UNITED STATES PATENT AND TRADEMARK OFFICE

APPLICATION NO.	FILING DATE	FIRST NAMED INVENTOR	ATTORNEY DOCKET NO.	CONFIRMATION NO.
10/561,532	12/19/2005	Ronald Dekker	NL02 1153 US	9985

Office Action Summary	Application No. 10/561,532	Applicant(s) DEKKER ET AL.	
	Examiner Michael B. Shingleton	Art Unit 2815

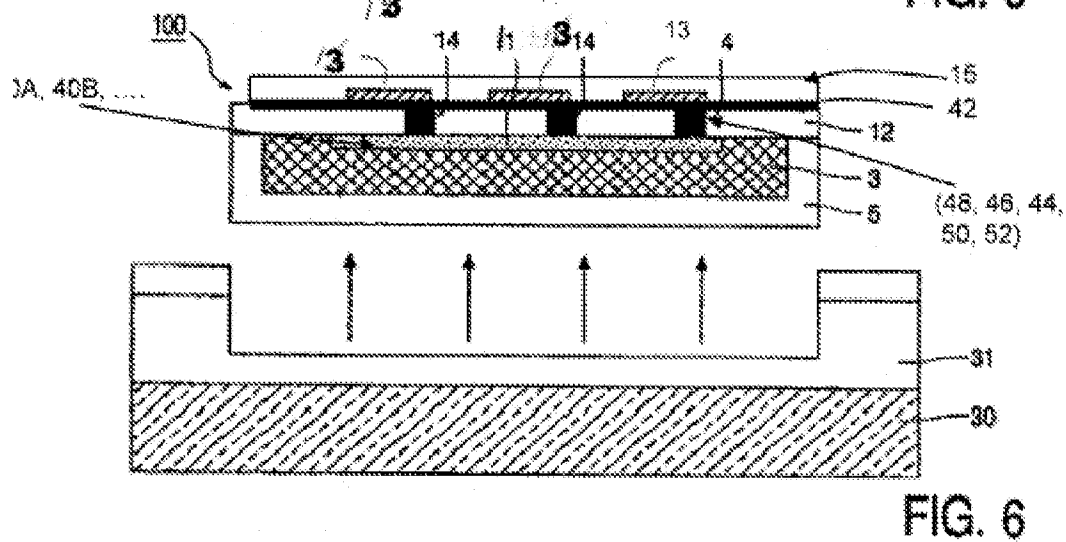
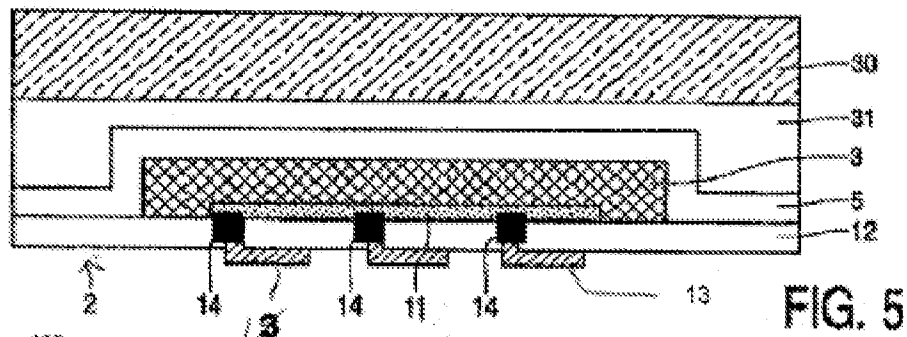
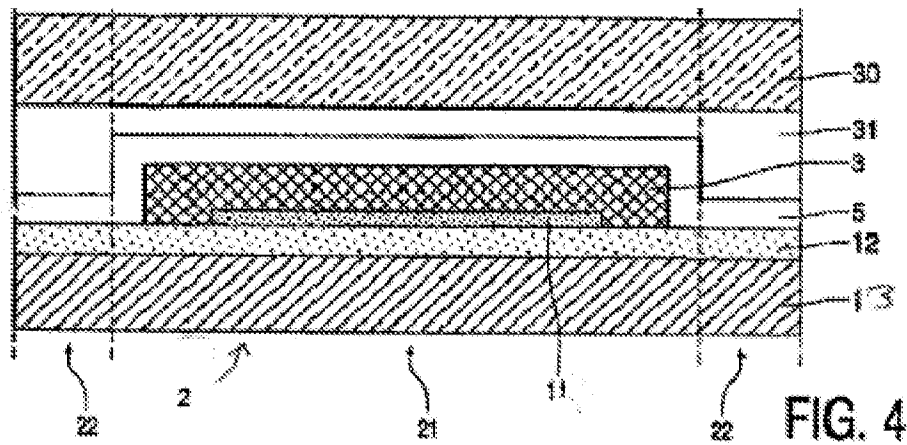
Claims 1, 3-7, 9 and 11 are rejected under 35 U.S.C. 112, first paragraph, as failing to comply with the written description requirement. The claim(s) contains subject matter which was not described in the specification in such a way as to reasonably convey to one skilled in the relevant art that the inventor(s), at the time the application was filed, had possession of the claimed invention. Newly proposed drawings and the specification contain new matter that is required to be cancelled in response to this office action. Specifically, one issue of new matter rests in the functional layer now indicated as 15 in the newly submitted drawings. There is absolutely no support for this in the original disclosure. In fact the original disclosure as well as the newly presented drawings clearly prove beyond any doubt that this "15" cannot be the functional layer. Here's why; in the marked up copy of the specification it states:

After that metal is provided in the apertures 14.

The originally Figures and the newly proposed figures clearly show what applicant now refers to as "functional layer 15" as being composed of exactly the same material as that in the apertures 14 which as noted above can only be metal (Note the cross hatching.). That's the original disclosure. And the specification has now been amended to say that the newly indicated 13/15 are base layer which is old element 13 and new element number 40A,40B. Showing two different compositions for the previously submitted "14" and "15" does not correspond to the original disclosure and is in fact contradictory to the original and thus is new matter. Also element 42 is new matter as well.

Thus there is absolutely no question that what applicant now points to as element 15 can only be that of metal which makes the newly added subject matter reciting that the functional layer is by example

includes electro-optical layers, etc. is clearly new matter never before presented. Note the new matter below of element 15 :

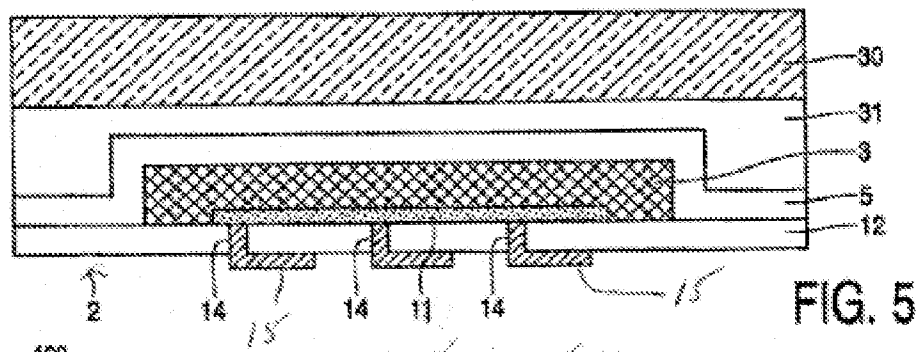
The drawings are objected to as failing to comply with 37 CFR 1.84(p)(4) because there are two different parts shown in newly presented Figure 7 that have the character “50” (Note the upper and lower number 50’s.). Different parts cannot have the same reference number See MPEP 608.02 and 37 CFR 1.84. Corrected drawing sheets in compliance with 37 CFR 1.121(d) are required in reply to the Office action to avoid abandonment of the application. Any amended replacement drawing sheet should include all of the figures appearing on the immediate prior version of the sheet, even if only one figure is being amended. Each drawing sheet submitted after the filing date of an application must be labeled in the

top margin as either "Replacement Sheet" or "New Sheet" pursuant to 37 CFR 1.121(d). If the changes are not accepted by the examiner, the applicant will be notified and informed of any required corrective action in the next Office action. The objection to the drawings will not be held in abeyance.

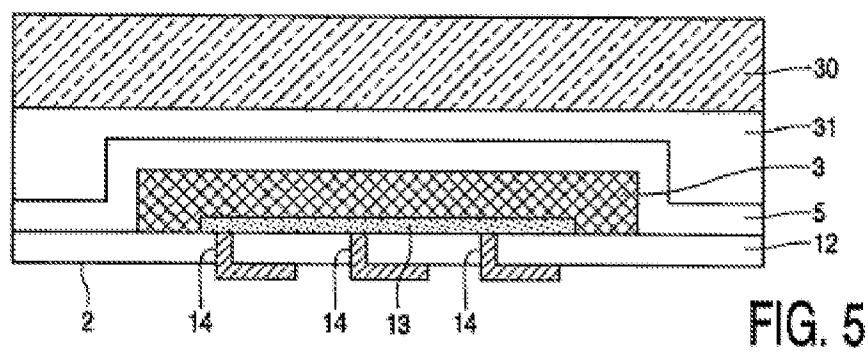
The previous amendment believed to be filed in February of '09 is objected to under 35 U.S.C. 132(a) because it introduces new matter into the disclosure. 35 U.S.C. 132(a) states that no amendment shall introduce new matter into the disclosure of the invention. The added material which is not supported by the original disclosure is as follows: Newly proposed drawings and the specification contain new matter that is required to be cancelled in response to this office action. Specifically, one issue of new matter rests in the functional layer now indicated as 15 in the newly submitted drawings. There is absolutely no support for this in the original disclosure. In fact the original disclosure as well as the newly presented drawings clearly prove that this cannot be the functional layer. Here's why. In the marked up copy of the specification it states:

After that metal is provided in the apertures 14.

The originally Figures and the newly proposed figures clearly show what applicant now refers to as "functional layer 15" as being composed of exactly the same material as that in the apertures 14 which as noted above can only be metal (Note the cross hatching.). That's the original disclosure.

Thus there is absolutely no question that what applicant now points to as element 15 can only be that of metal which makes the newly added subject matter reciting that the functional layer is by example includes electro-optical layers, etc. is clearly new matter never before presented. Note the new matter below of element 15 :

Applicant is required to cancel the new matter in the reply to this Office Action.

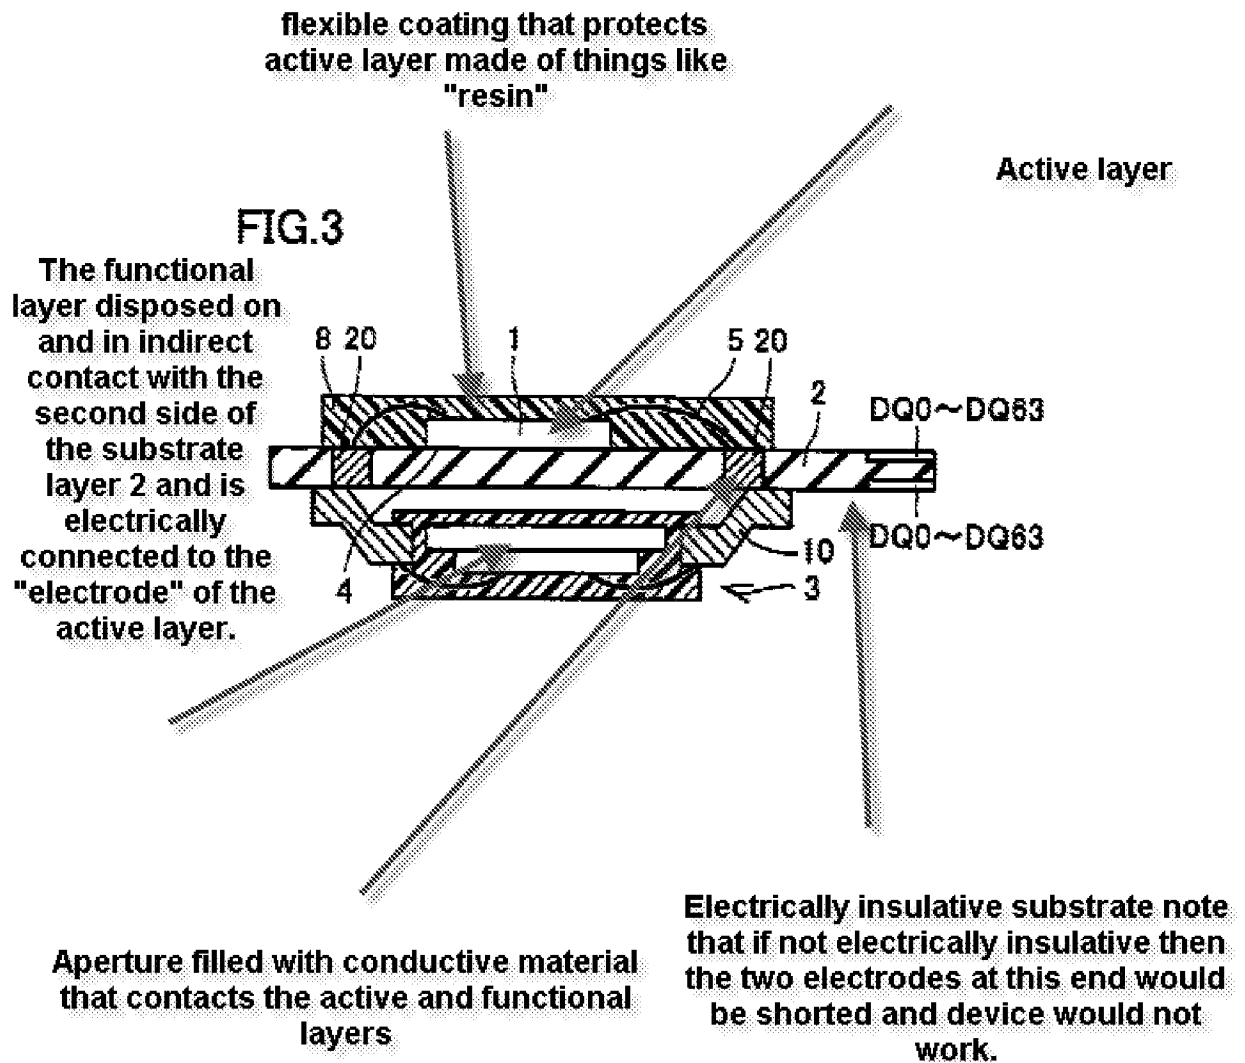
Claim 1 is so so extremely broad. First of all applicant still has not provided a proper drawing to an invention where the functional layer is on the “second side of the substrate”. What applicant now points to as element 15 is composed of the same exact material as that of 14 with is pure conductor as presented by the original disclosure. This just cannot be the functional layer, period. Again what was shown in the original disclosure was that of pure conductor and thus there continues to be clear new matter that must be cancelled in response to this office action. However, as stated above claim 1 is so so so extremely broad.

In essence claim 1 has a circuit on one side and a circuit on the other side of a substrate with a through hole connecting the two circuits. The only other thing added besides just stated is that there is a "flexible coating" formed on the "first side" of the substrate acting as a protective cover. Applicant should be well aware of the numerous flexible circuit boards that exist with through holes where the active or functional elements(layers) are mounted on both sides of the flexible circuit board and connected to each other via the through holes. More "rigid" versions like motherboards common in computers also are commonly known to exist with active and functional layers but all versions are flexible to some degree and applicant just has not claimed nor is there any support in the original disclosure to the degree, i.e. just how flexible is flexible as meant by applicant. The examiner wants to help applicant as much as possible to get to allowable subject matter and because there is no support for the degree of flexibility the examiner cannot suggest a limitation as to the degree as this would introduce new matter into the specification that has already been plagued with numerous errors. Matsumoto has been provided to show that the invention as set forth in claim 1, notwithstanding the new matter that exists in the present application, is anticipated by the prior art. The following reproduced drawing should make it clear that claim 1 is clearly anticipated but a few points are discussed as well to further emphasize this point. Applicant says that the active layer includes "at least one switching element". Well many things can be consider a "switching element" and as Matsumoto intends to use memory chips as the active layer the memory devices contained therein can be called "switching elements" as there state i.e. a 1 of a 0 is switchable. Resin is clearly flexible and is listed as one of the "flexible materials" by applicant. The term "monolithic" is likewise very broad. Clearly even applicant's invention is not "formed from a single crystal". Applicant's invention it is like that of Matsumoto "consisting of or constituting a single unit" i.e. monolithic. Should applicant like to have the examiner read a term like "monolithic" much more narrowly than is common practice then applicant should be aware of the recent case-law of Halliburton Energy Services, Inc v M-I LLC, Fed. Cir, 2007-1149 that states: **"[b]ecause claims delineate the patentee's right to exclude, the patent statute requires that the scope of the claims be sufficiently definite to inform the public of the bounds of the protected invention, i.e., what subject matter is covered by the exclusive rights of the patent. Otherwise, competitors cannot avoid infringement, defeating the public notice function of the patent claims."** As recited in the above Halliburton decision the court says **"We note that the patent drafter is in the best position to resolve ambiguity in the patent claims, and it is highly desirable that the patent examiners demand that applicants do so in appropriate circumstances so that the patent can be amended during prosecution rather than attempting to resolve the ambiguity in litigation."** Also note that the Halliburton decision relates to the situation where applicant is very
